SUBJECT: **Customer Satisfaction Program 21B49 - Supplement #1**
 Certain 2021 Model Year Bronco Vehicles Equipped with a Hard Top Roof
 Roof Panel Delamination

REF: **Customer Satisfaction Program 21B49**
 Dated September 30, 2021

New! REASON FOR THIS SUPPLEMENT

Technical Information - Dealership: Updated with revised directions regarding hard top panels and rear cap assembly disablement and photo submission requirement. As a result, the Labor Allowances have also been updated.

FIGURE 22

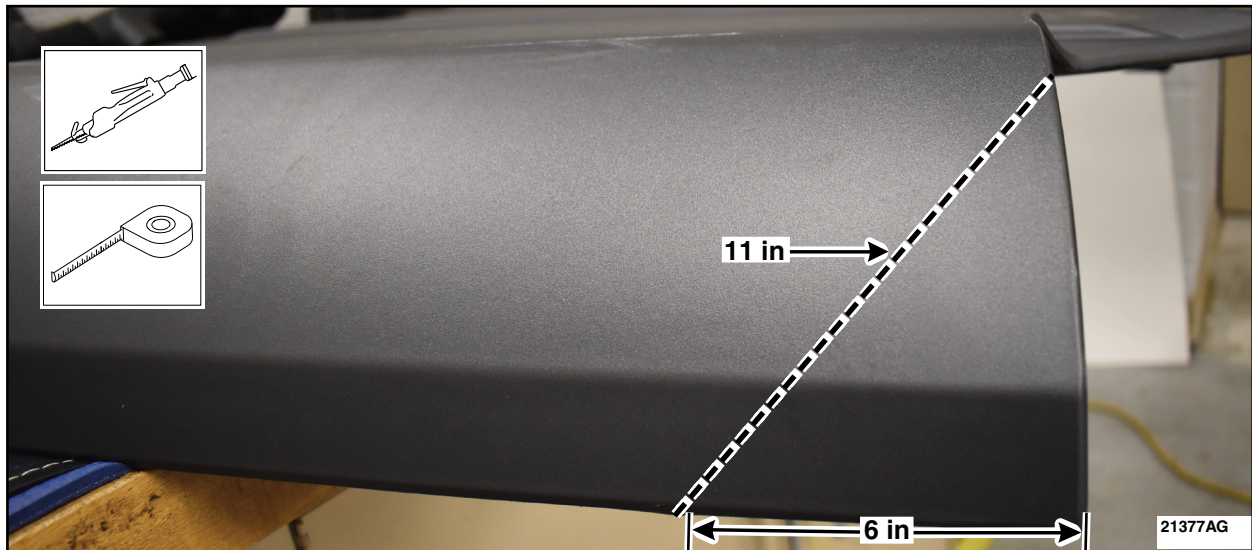
NOTE: The hard top panels and hard top rear cap assembly disablement must take place at two different corner locations on each panel and rear cap assembly and it will have to be captured in the photo evidence. The hard top panels and the hard top rear cap assembly must not be able to be reused after disablement. See Figures 22 and 23.

1. **ALL** hard top panels and hard top rear cap assembly removed from vehicles must immediately be made unusable by cutting two corners of each hard top panel and hard top rear cap assembly at a minimum of 6 inches in length from the corner, and cutting on an angle through the panel at an minimum of 11 inches making sure to cut through the weather seal where applicable. See Figures 22 and 23.

FIGURE 23

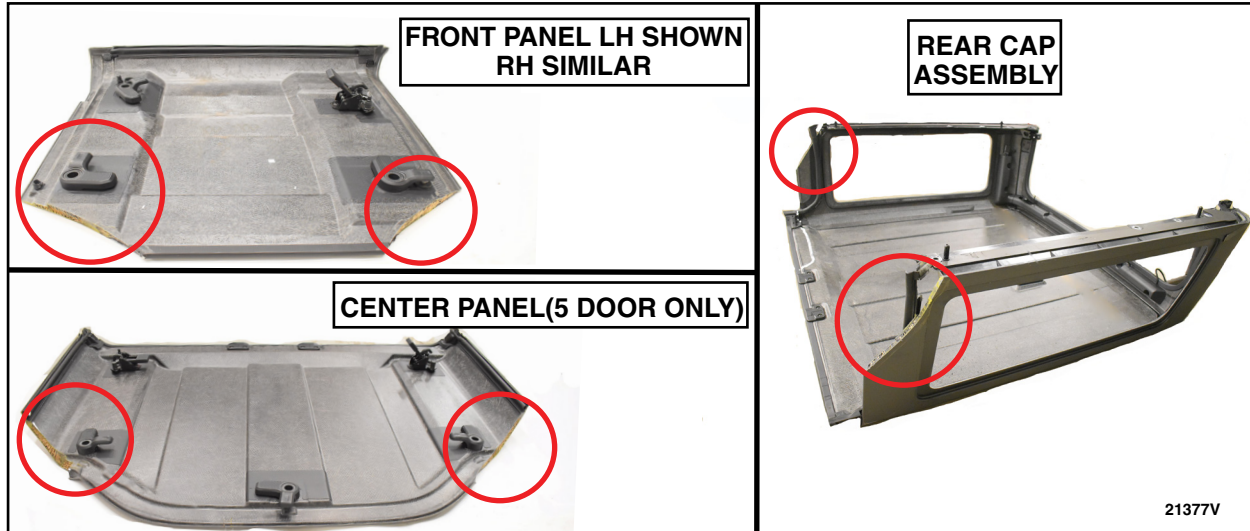
2. Submit clear photos of **ALL** the disabled hard top panels and hard top rear cap assembly.
